MtIntosh MI-350

SERVICE INFORMATION

SERVICE BULLETIN

ELIMINATION OF SELF TURN-OFF

REAR OF UNIT

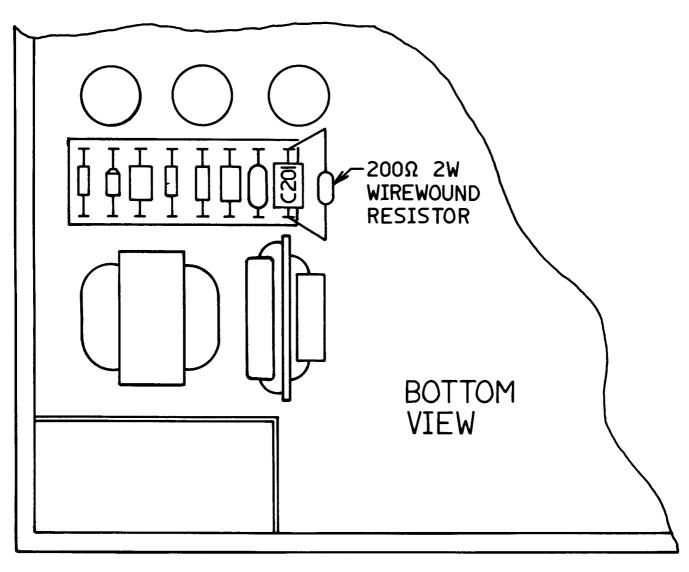
PURPOSE OF MODIFICATION: To prevent amplifier from turning off at maximum output.

Step 2 Add resistor in parallel with capacitor C201 (shown at circuit breaker on schematic).

1 139-069 200Ω 2W wirewound resistor

Step 1 Remove bottom cover.

Step 3 Replace bottom cover.
